# Riverside Energy Park

## Applicant's response to London Borough of Bromley Deadline 5 Submission

**8.02.72**

Figure 1: Bromley AQMA

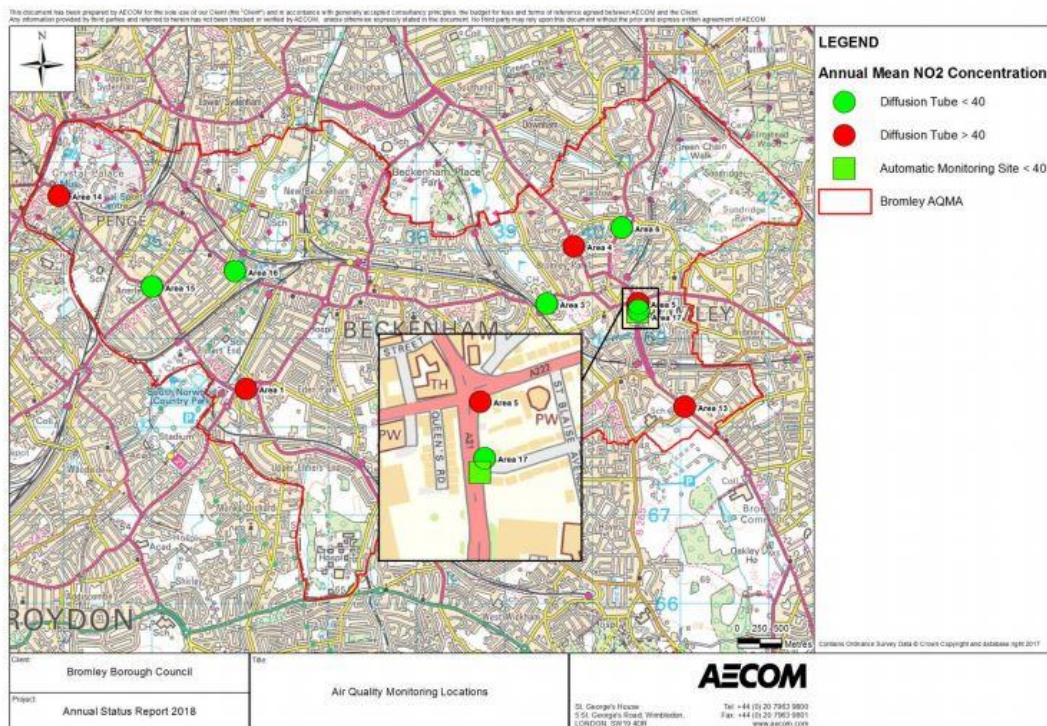
1.2.4 The location of the London Borough of Bromley AQMA (which contains the two Focus Areas referenced by the Respondent) is shown in **Figure 1**

overleaf<sup>1</sup>. The AQMA is declared for exceedances of the annual mean nitrogen dioxide objective of 40 µg/m<sup>3</sup>.

1.2.5 The nearest point of the AQMA is approximately 12 kilometres to the south west of the Energy Recovery Facility (ERF) emission point. The AQMA is well outside of the zone of impact of emissions from the ERF as shown in Figure 5 for annual mean NO<sub>2</sub> impacts in the **Applicant's Response to Air Quality Matters (8.02.70)** submitted at Deadline 7. NO<sub>x</sub> emissions from the ERF will therefore not have a significant impact on Bromley's AQMA or the two Focus Areas.
